FED. ROAD DIS. NO.	STATE	FED. AID PROJ. NO.	FISCAL YEAR	SHEET NO.	TOTAL SHEETS
HAWAII	HAW.	I-H3-1(59)	1993	ADD.31	211

STATE OF HAWAII DEPARTMENT OF TRANSPORTATION HIGHWAYS DIVISION	
GRADING NOTES EROSION AND SEDIMENT CONTROL MEASURES	
INTERSTATE ROUTE H-3 F.A.I. PROJECT NO. I-H3-1(59)	
SCALE: AS NOTED	DATE: JUNE 1993
SHEET No. D1 OF 32 SHEETS

ADD. 31

9/30/93	REVISION
DATE	REVISION
STATE OF HAWAII DEPARTMENT OF TRANSPORTATION HIGHWAYS DIVISION	
GRADING AND DRAINAGE PLAN	
STA. 386+00 TO STA. 397+00	
INTERSTATE ROUTE H-3 F.A.I. PROJECT NO. I-H3-1(59)	
SCALE: 1" = 40'	DATE: JUN 1993
SHEET NO. 03 OF 32 SHEETS

PROFILES
DRAIN LINES "S," "T" AND "U"
INTERSTATE ROUTE H-3
F.A.I. PROJECT NO. I-H3-1(59)

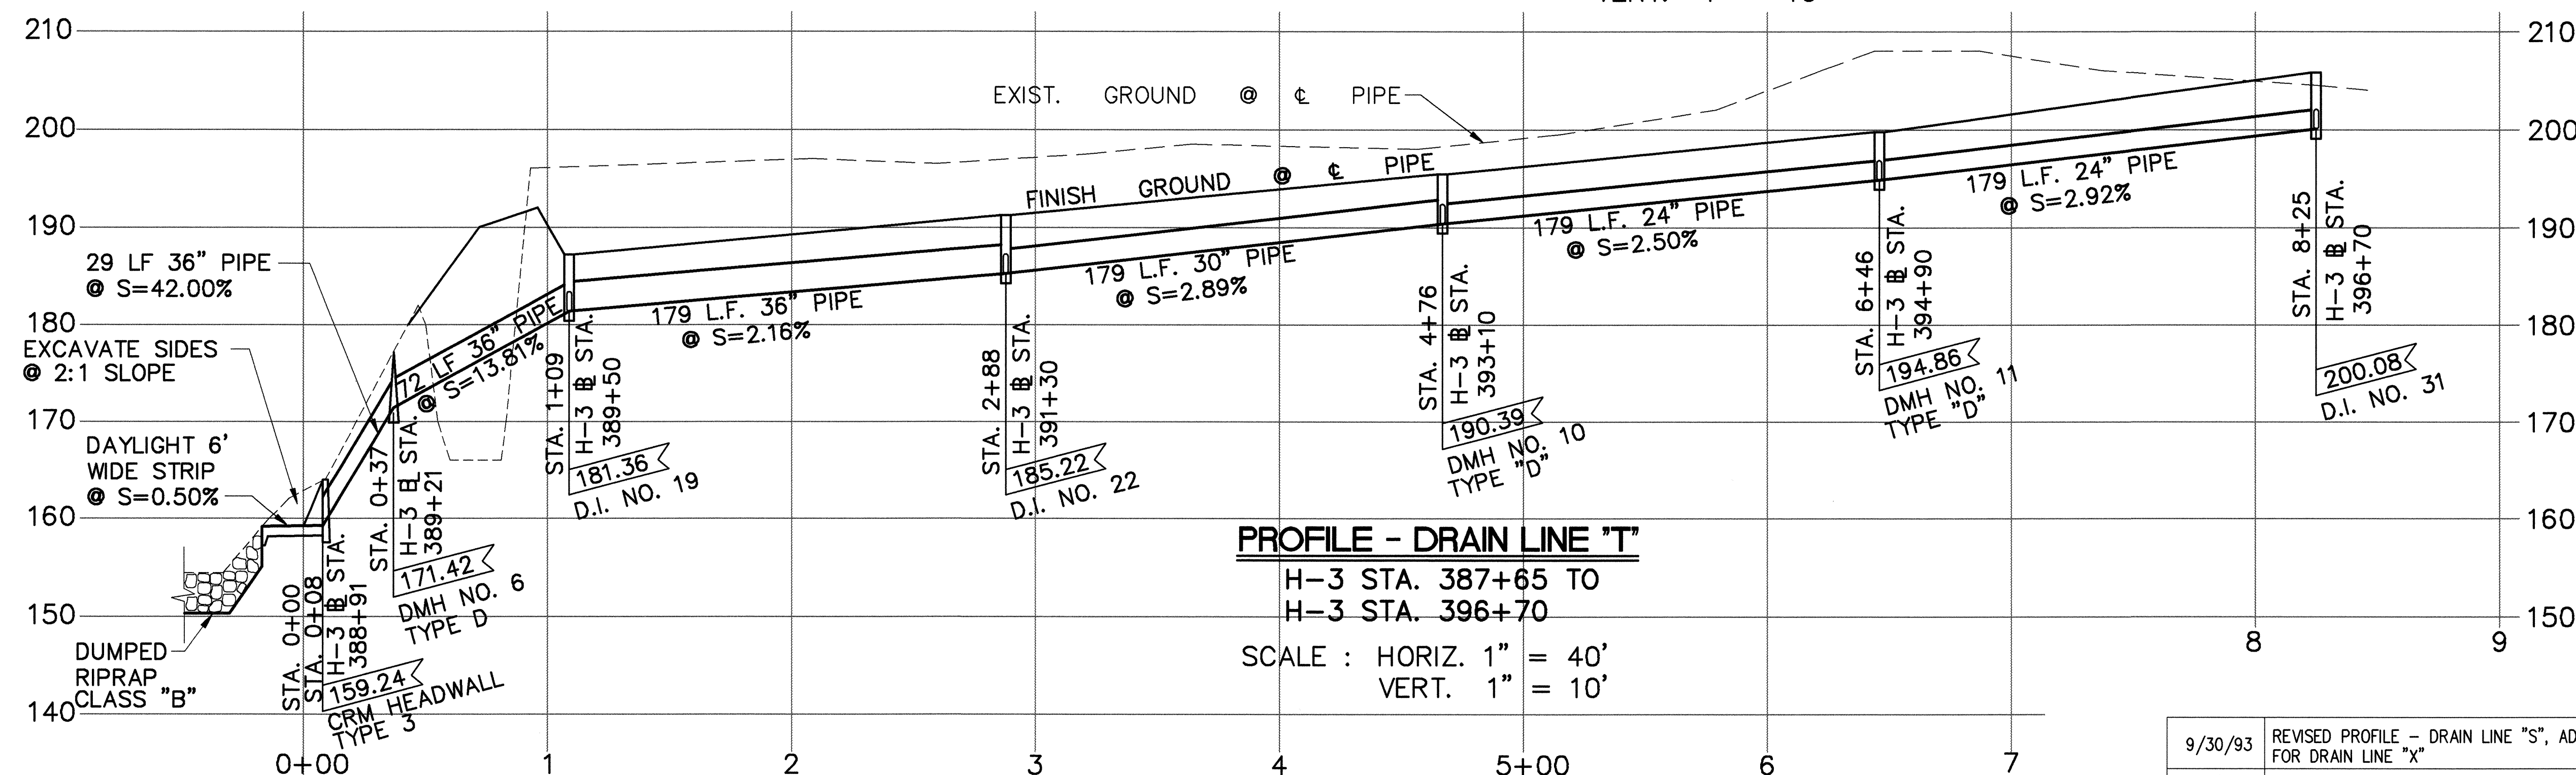
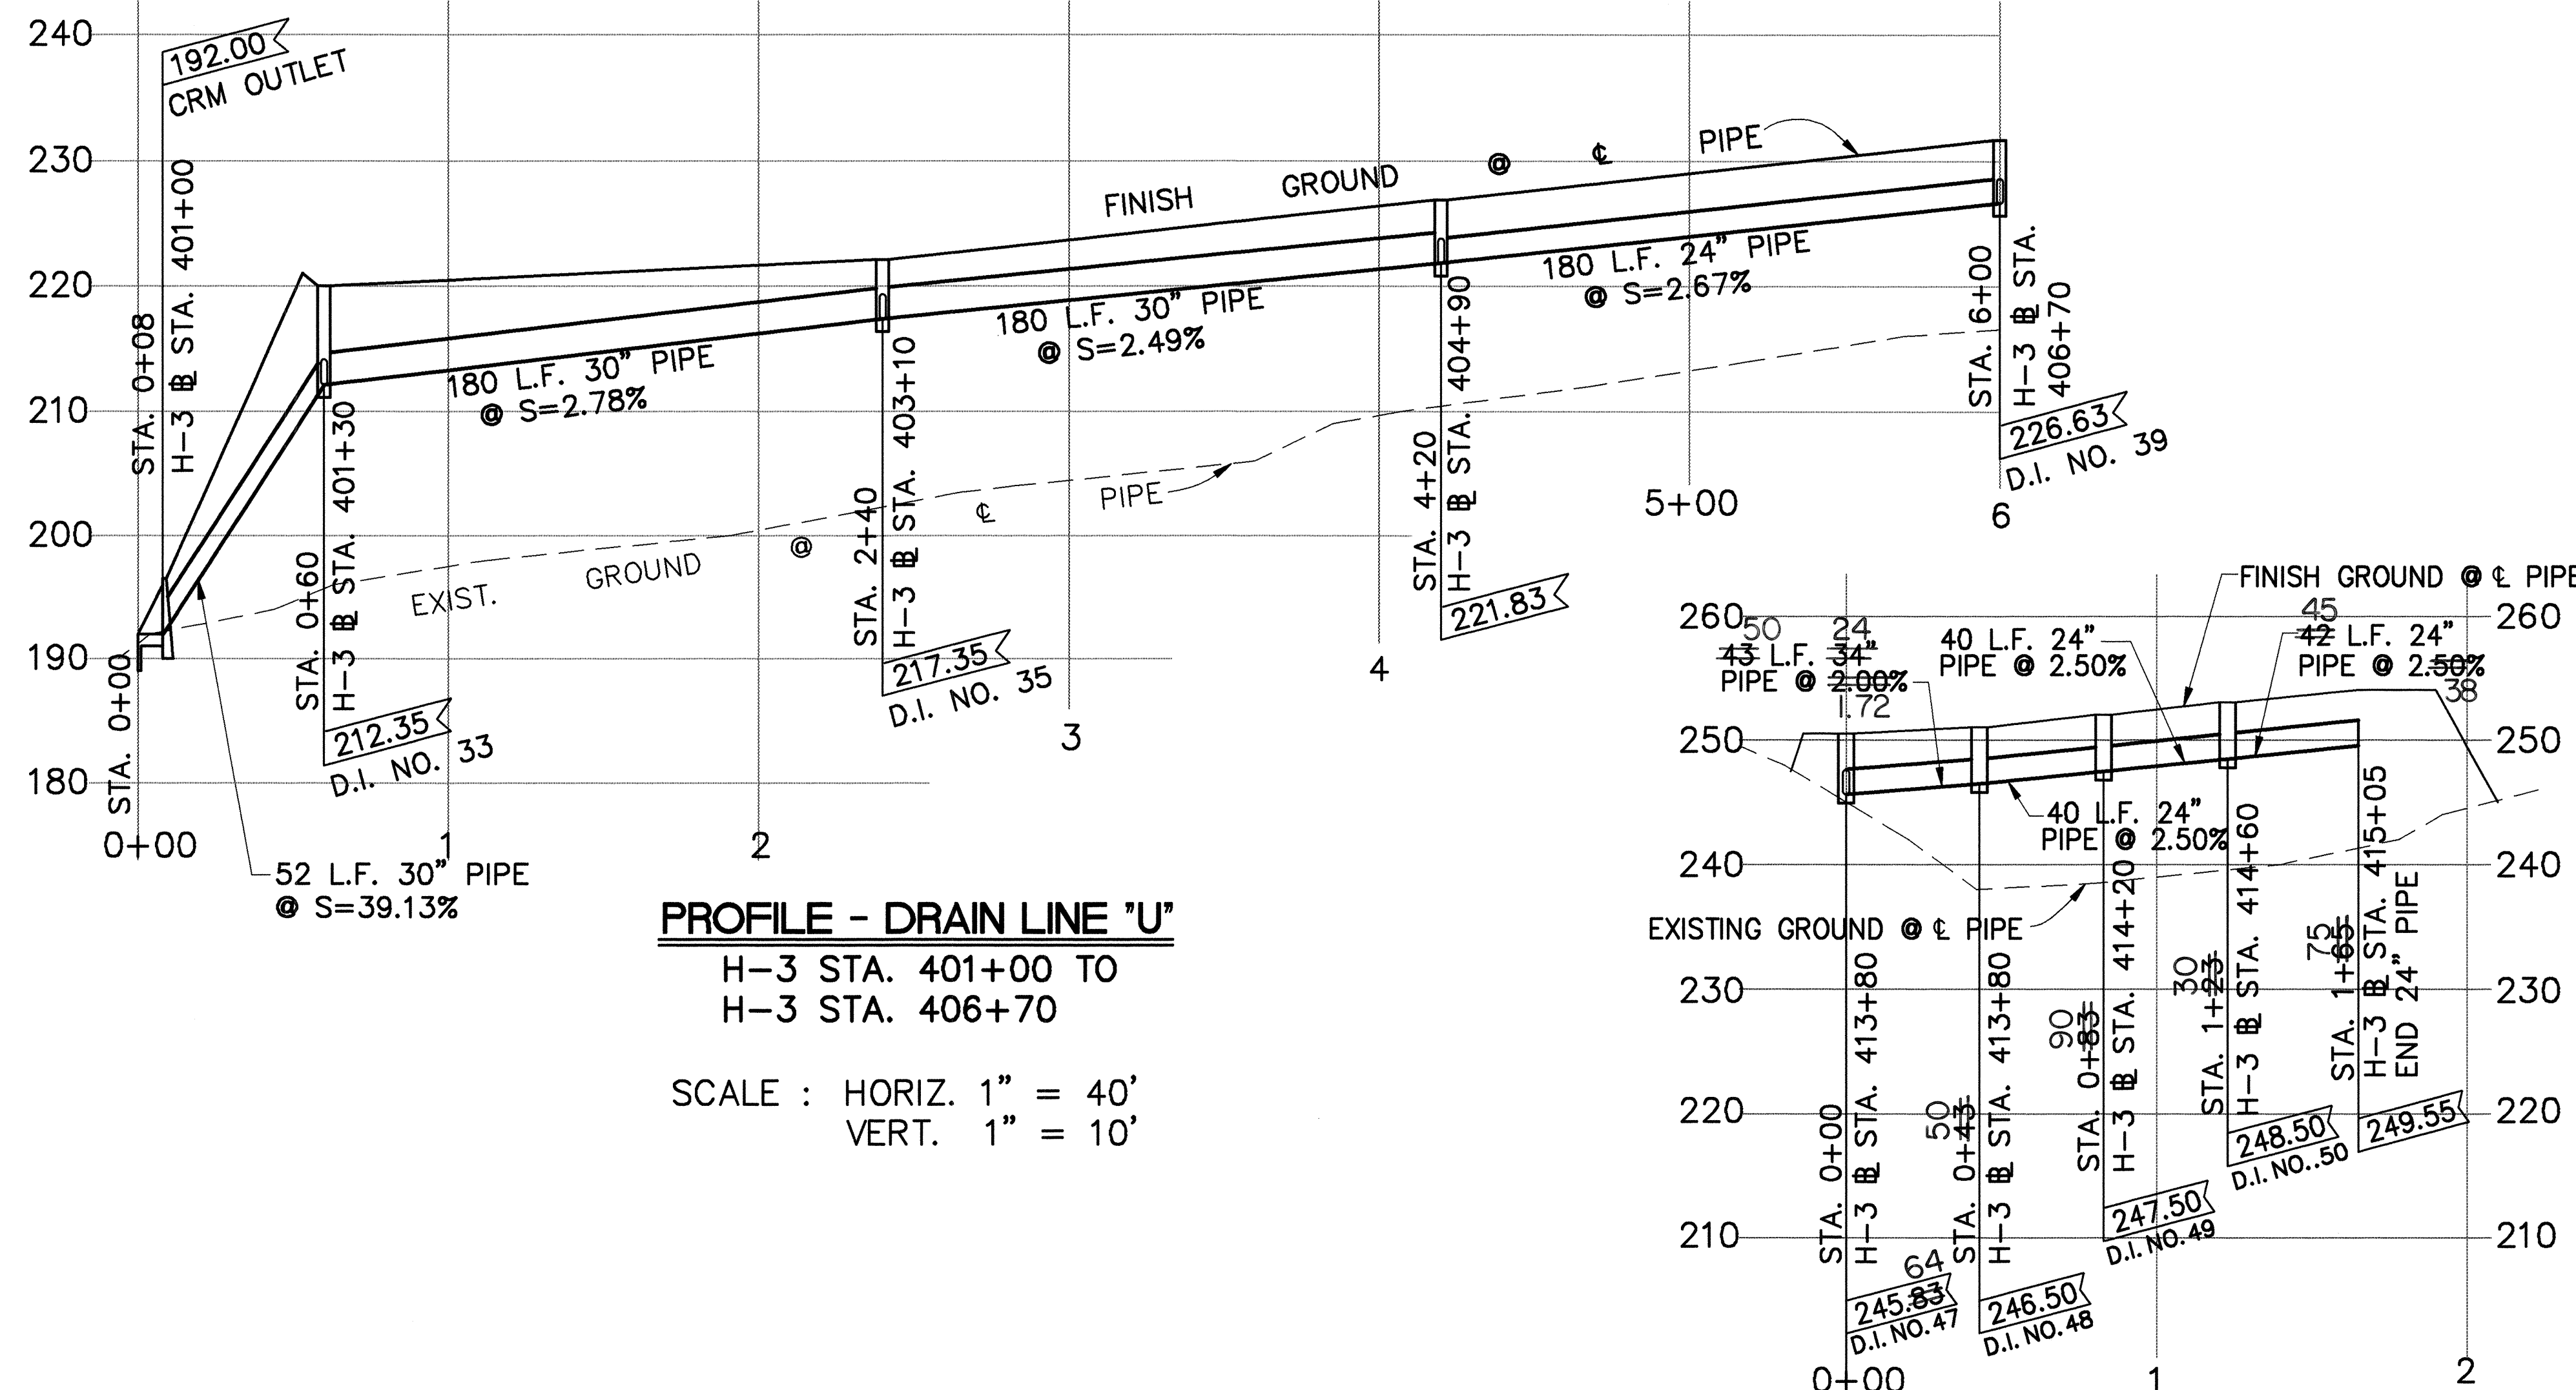
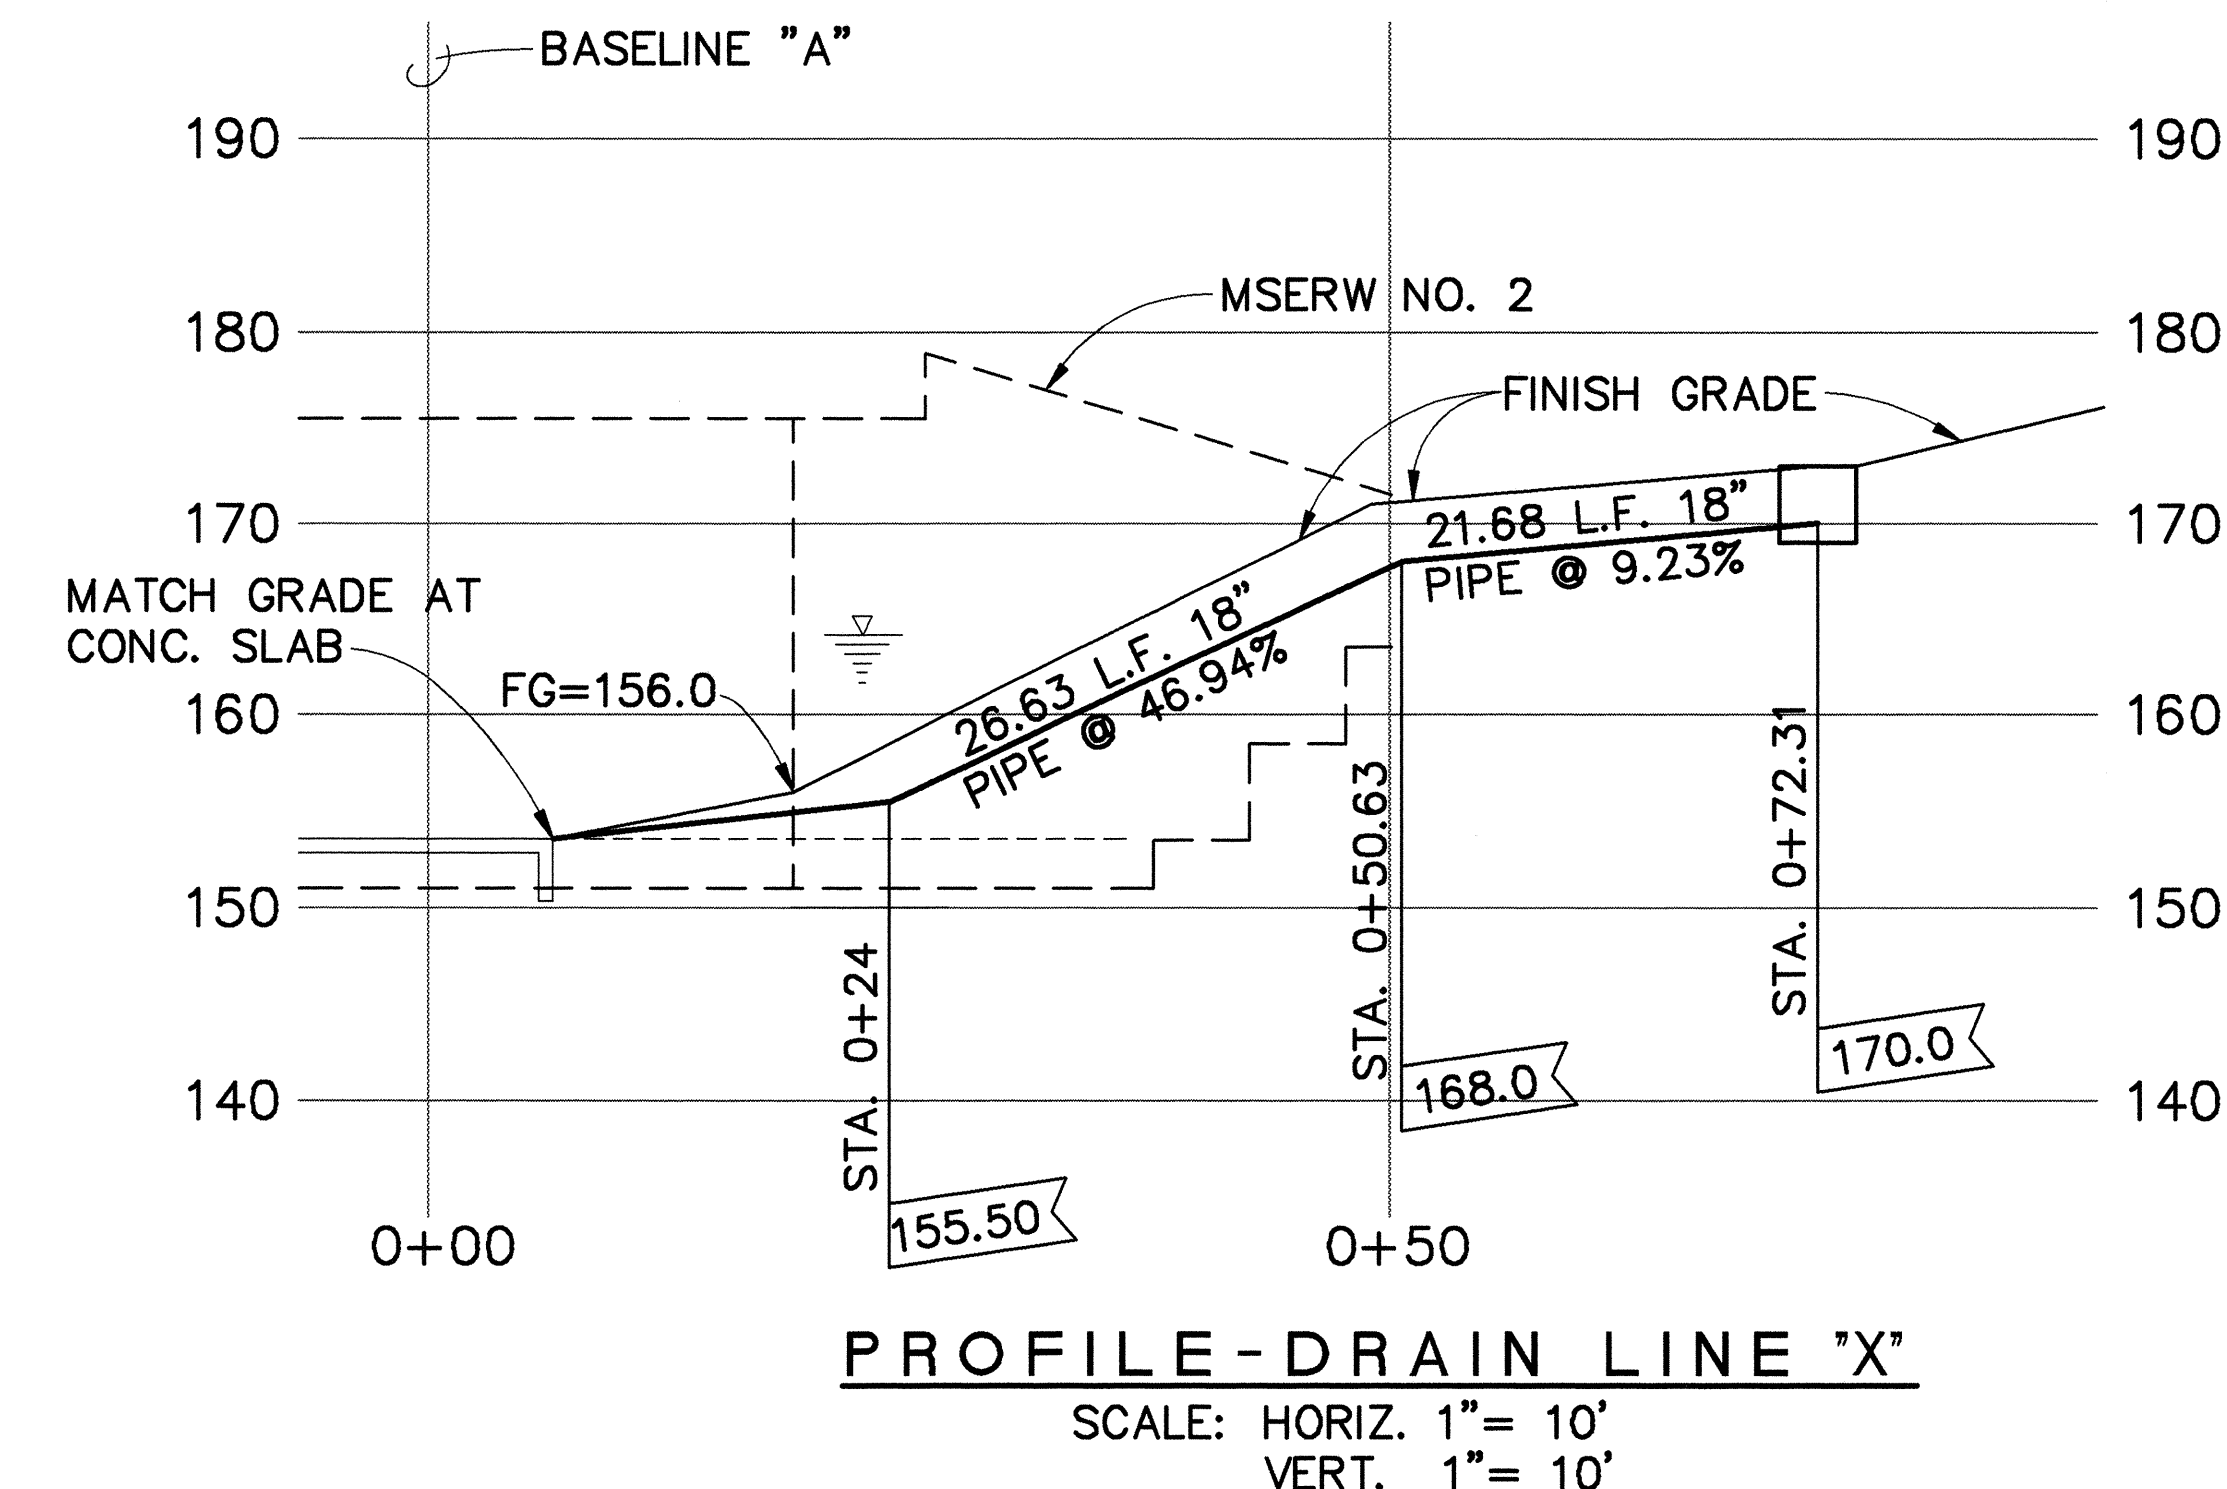
9/30/93	REVISED PROFILE - DRAIN LINE "S", ADDED PROFILE FOR DRAIN LINE "X"
DATE	REVISION
